# Service Bulletin

S.B. No: 187

**Title:** INSPECTION FOR CLEARANCE BETWEEN RUDDER PEDAL AND MIXTURE/PROP. SPEED BRACKET AND FOR GROUND TOWING DAMAGE. ALSO INCLUDES GENERAL RUDDER PEDAL CLEARANCES.

**Applicability:** T67M200 (Works No. 2264 & 2265 only), T67M260 and T67M260-T3A.

**FIGURE 1**  
**SHOWING CLEARANCE MIXTURE/PROP SPEED BRACKET TO No. 3 PEDAL**

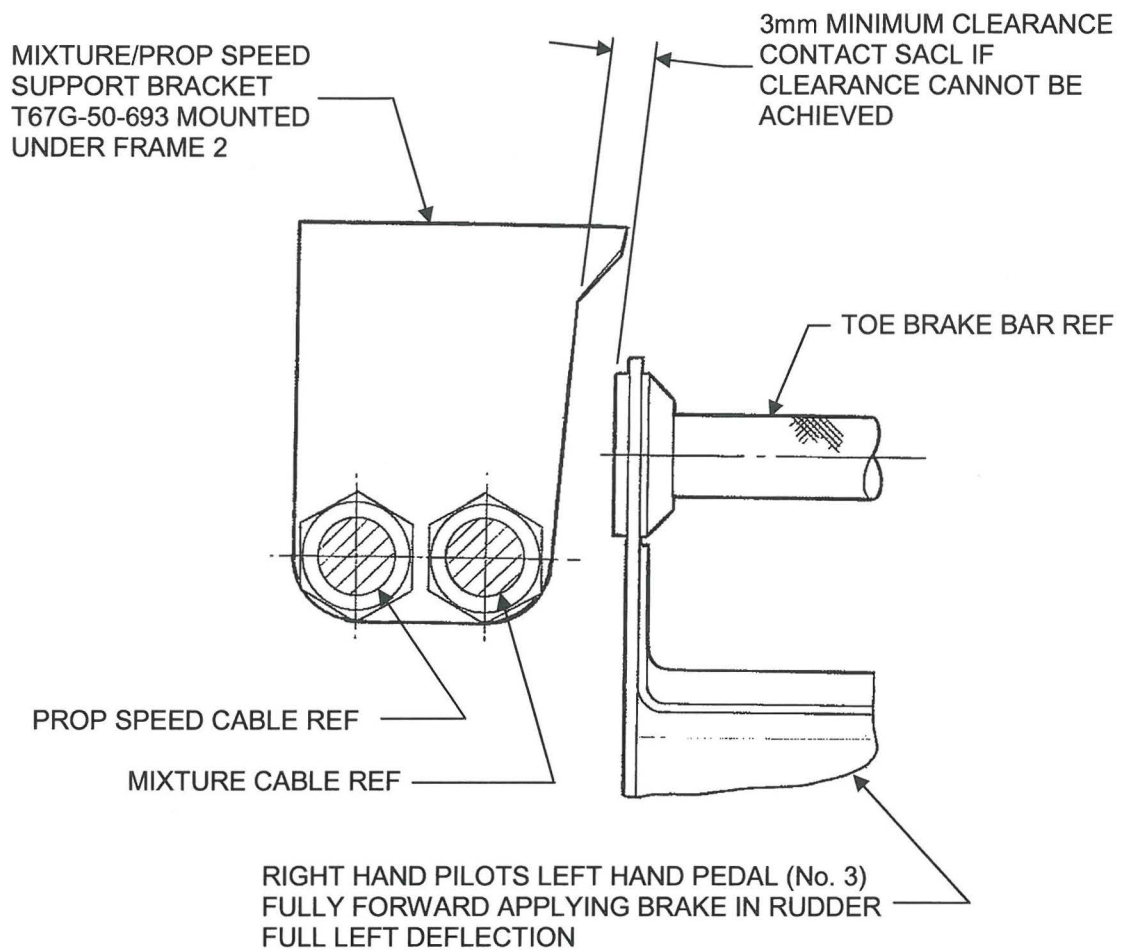
1. With Right Hand pilots left pedal (Pedal No. 3) adjusted fully forward, with left rudder applied, apply brake together with a left hand side force on the pedal. Check for clearance on mixture/propeller speed cable support bracket. Refer Figure 1.

2. Clearance should be a minimum of 3mm. Figure 1 refers.
  - 2.1 If the clearance is less than 3mm, the following inspection and corrective actions, paragraphs 3 to 32, shall be carried out in order to increase the clearance up to the required minimum of 3mm.

FIGURE 2

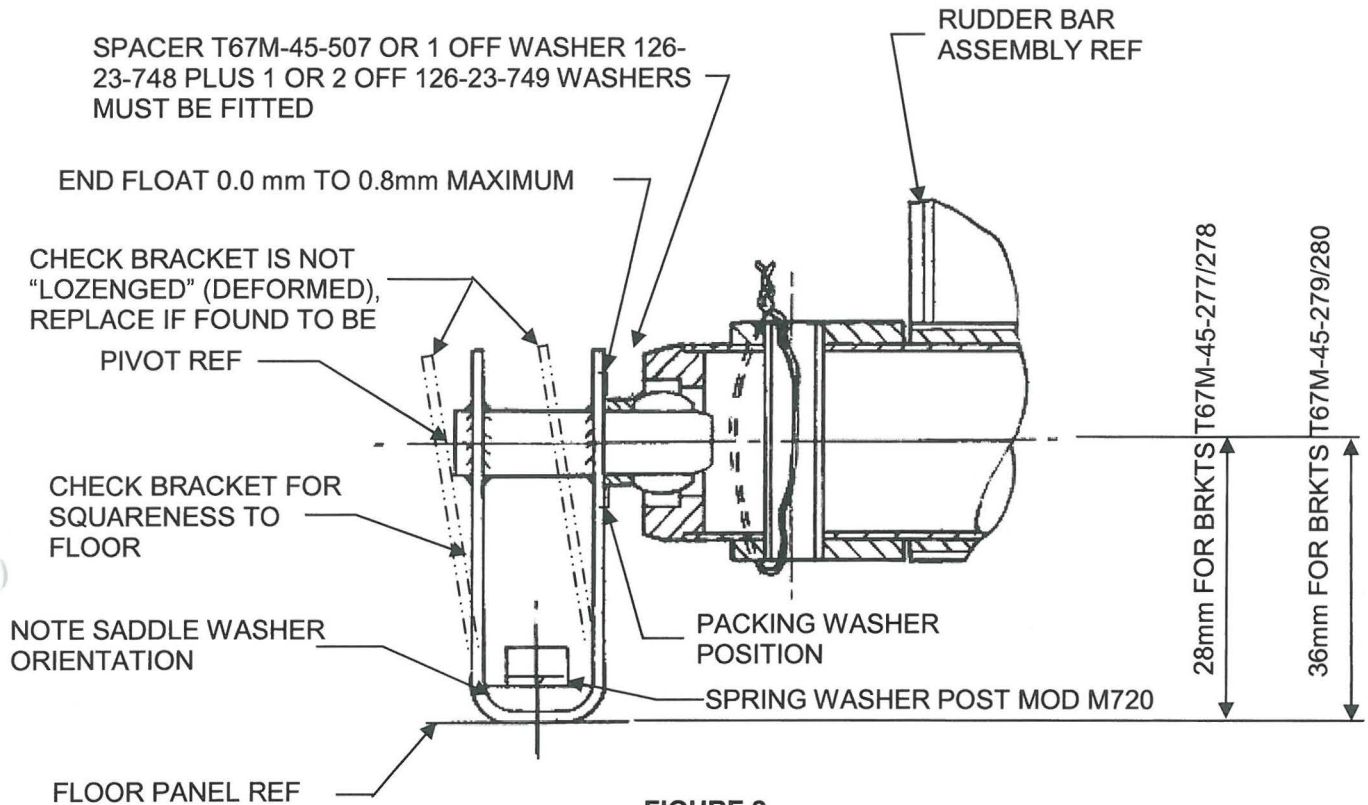
4. Check rudder pedal bar end float is no greater than 0.8mm. Acceptable end float is 0.0mm to 0.8mm. If end float is greater than 0.8mm then rectify IAW paragraph 14. Refer Figure 2.

14. Referring to Figure 2 ensure at each rudder bar pivot position that there is one spacer T67M-45-507 OR one off washer 126-23-748 and up to a maximum of two off washers 126-23-749, i.e. 3 washers maximum.

If end float greater than 0.8mm, then 1 off packing washer may be added at each pivot position as required, i.e. 126-23-105 washer or 126-23-748 washer or 126-23-749 washer.

FIGURE 3

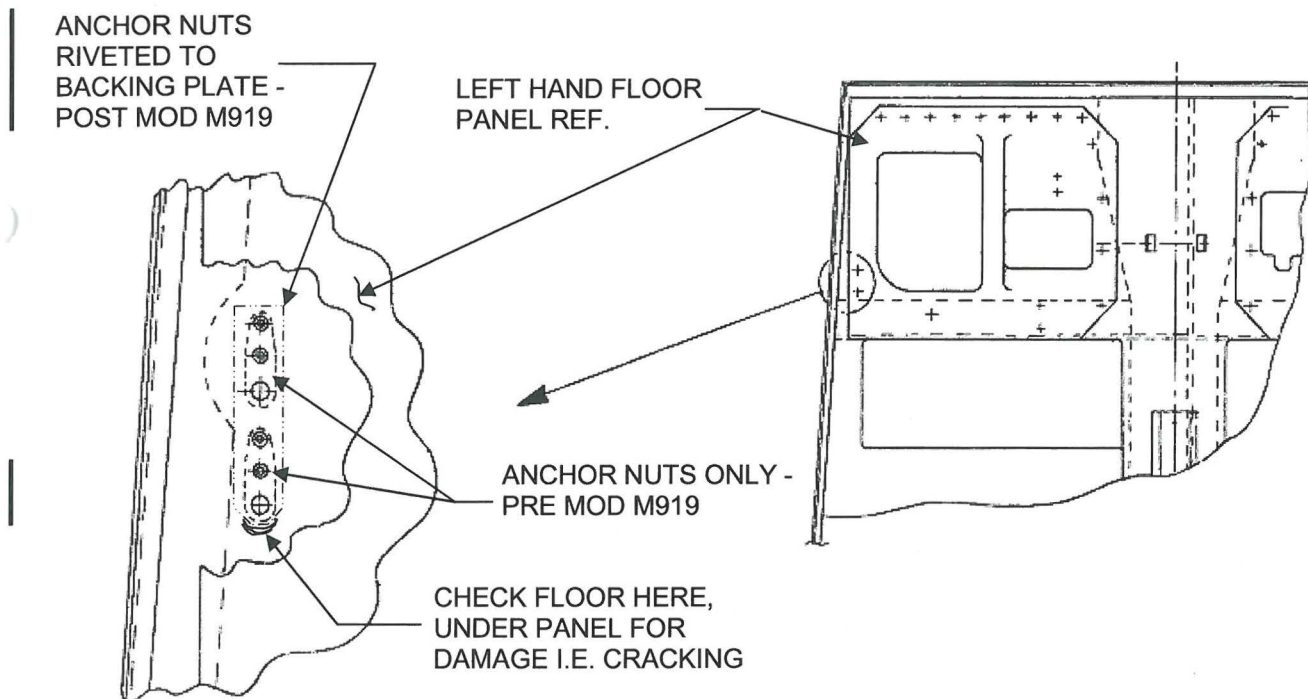
5. Check that the Rudder Pedal bar port outboard support bracket, ref. Figure 2 and 4, is square to floor and not "lozenged" and there is no deformation to its base. Check floor under removable floor panel in area of bracket, inspect for cracking which could allow the bracket to lean. Remove the floor panel, and on Post Mod M945 aircraft fuel panel on lower fuselage front may be removed, check for signs of cracking in the floor around the anchor nuts on Pre Mod M919 aircraft or the anchor nut mounting plate Post Mod M919 aircraft, refer to Figure 3. Any GRP damage will be shown as a white shadow on the GRP, with cracking felt as a rough edge. A light shining up through the floor will show a shadow.

6. If floor under port outboard support bracket position is found to be cracked or broken then repair IAW DOI T67C-149 issue 4 and subsequent, incorporating Mod M919. If Mod M919 has been previously incorporated and floor is damaged, inform SACL.

FIGURE 4

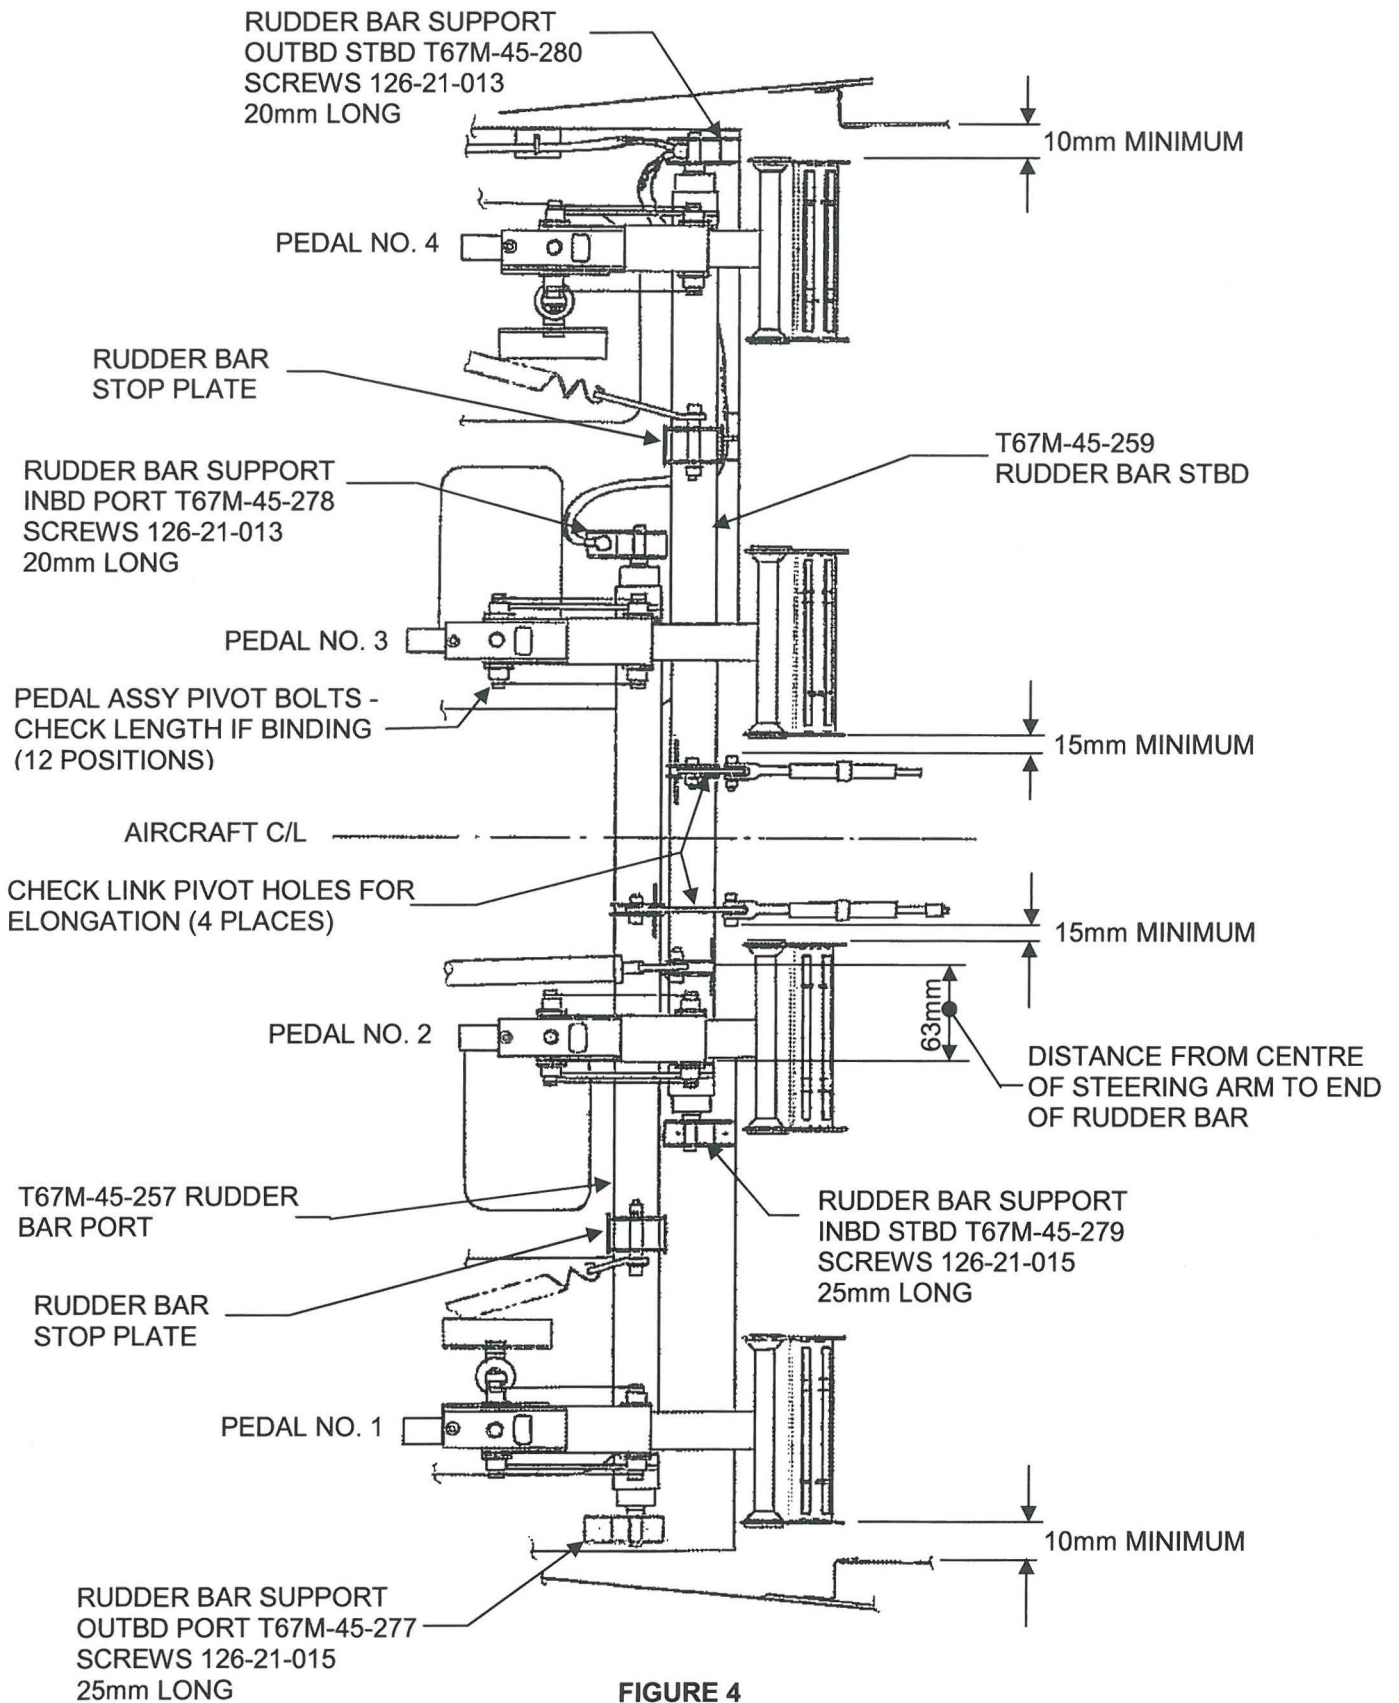
9. Check the remaining rudder bar support brackets, are square to floor and are not "lozenged" and there is no deformation to their bases, reference Figures 2 and 4. If any bracket is found to be suspect replace with new item. Check floor under any damaged support bracket by removing panel. Ensure washers and brackets are correctly assembled refer paragraph 8 above. Inform SACL of any damaged bracket or additional floor damage. Assemble item as per paragraph 8 and ensure end float is as stated in paragraph 14. Ensure bonding leads are correctly fitted, carry out bonding check refer relevant aircraft's Maintenance Manual. Ensure correct length screws for attaching the rudder bar support brackets have been fitted in the correct positions, refer Figure 4.

Note 2: Note rudder stop plates, positions indicated on Figure 4, are permitted with deformation assuming full rudder movement and clearances have been achieved and there is no cracking in the welds supporting the stop plates, if in doubt return rudder bar to SACL for rework.

19. Upon completion of rudder movement set-up ref. Paragraph 17 above, ensure minimum clearances of trim panel to pedal side plates and rudder cable to pedal side plates are met Refer Figure 4. Refer paragraph 14 for packing washers.

PEDAL NO. 2 TO HEATER BOX CLEARANCE

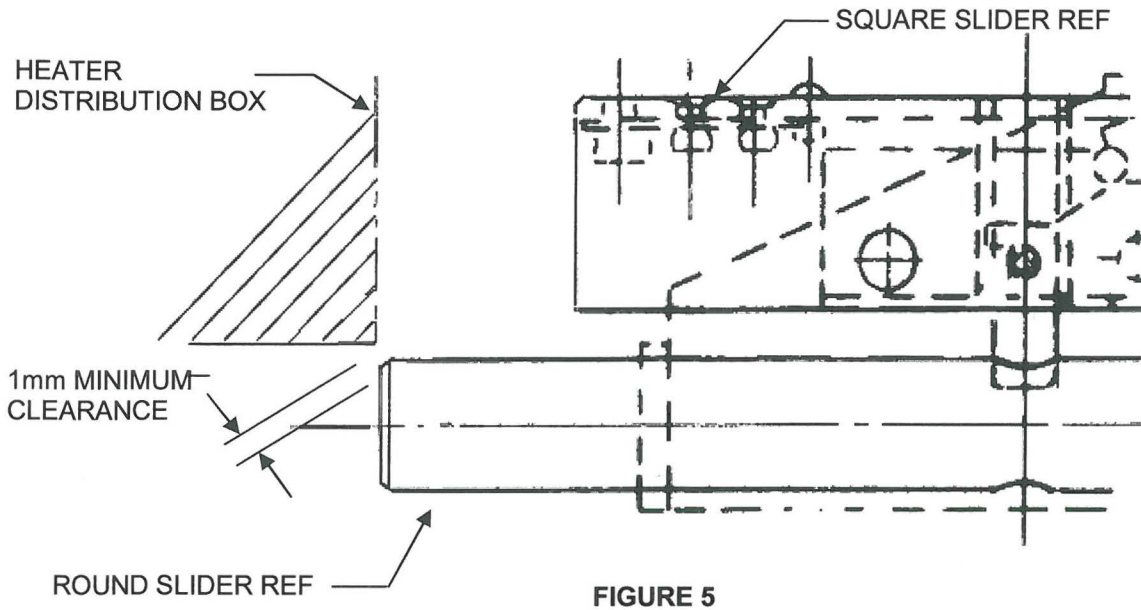
20. Ensure clearance of the no. 2 pedal slider to heater box clearance, is greater than 1mm, Figure 5 refers. Inform SACL if clearance is not achievable.

PEDAL NO. 2 TO STEERING ARM INTERFACE

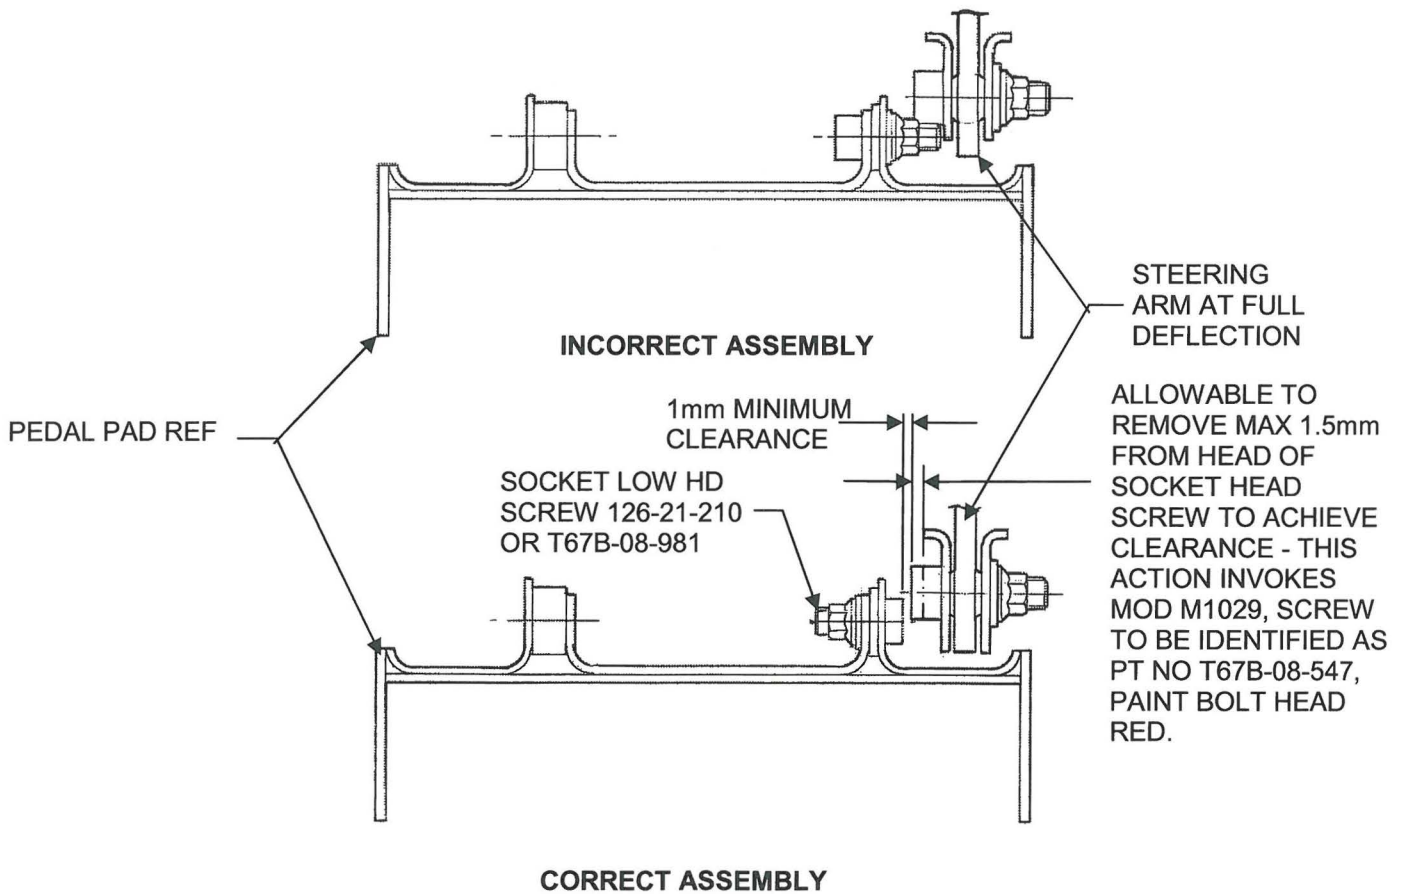
23. Ensure head orientation of rudder cable link low pan head bolt T67M-45-570 is outboard. T67M260 Maintenance Manual Figure 5-7 refers.
24. Ensure Pedal no 2 Pedal pad pivot bolt head height is less than 5mm and orientated, as shown in Figure 6. A minimum of 1mm clearance is required, if not, fit part no 126-21-210 or T67B-08-981, this invokes Mod M671 "Introduction of Low Head Rudder Pedal Pad Pivot Bolts – Pedal No. 2". If clearance is not still achieved check distance of steering arm from bar end, Figure 4 specifies. If the distance is incorrect, then return rudder bar to SACL for re-worked/new item. Alternatively if clearance of 1mm is still not achievable remove up to a maximum of 1.5mm from the steering arm screw this invokes Modification action M1029, Figure 6 refers, and paint modified screw head red.

FIGURE 7

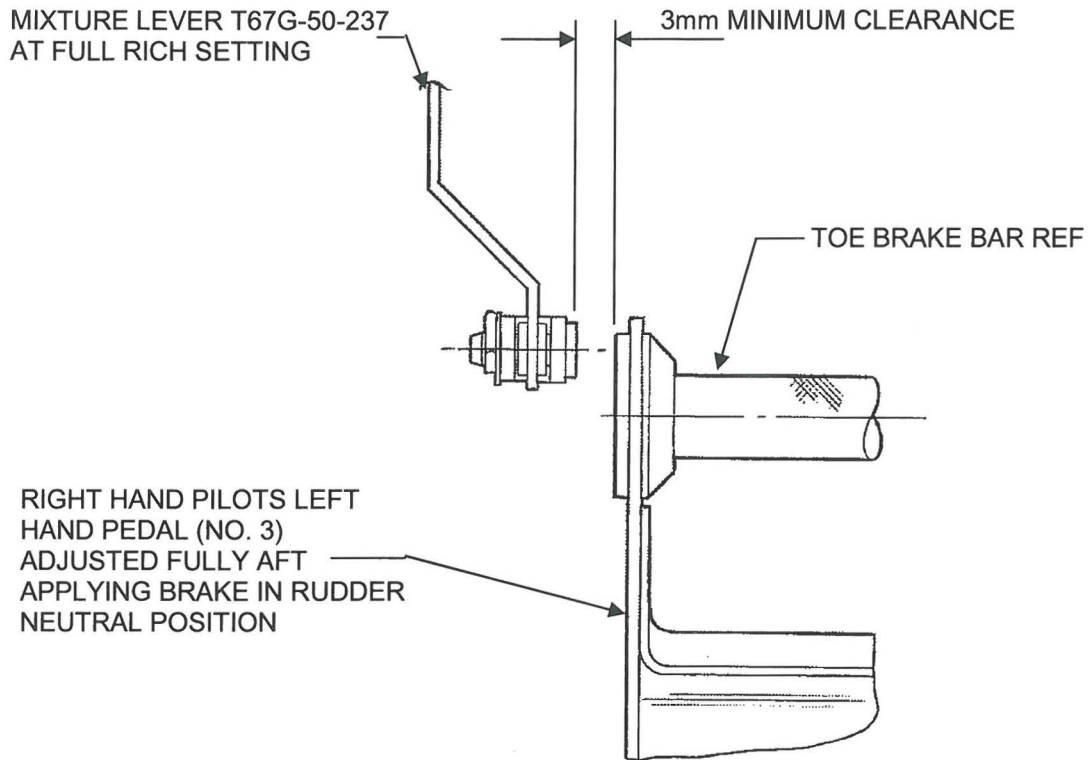
27. Ensure, that a minimum clearance of 3mm is achieved between Pedal No 3 and Mixture Lever operating arm, refer Figure 7. Refer paragraph 14 for packing washers.
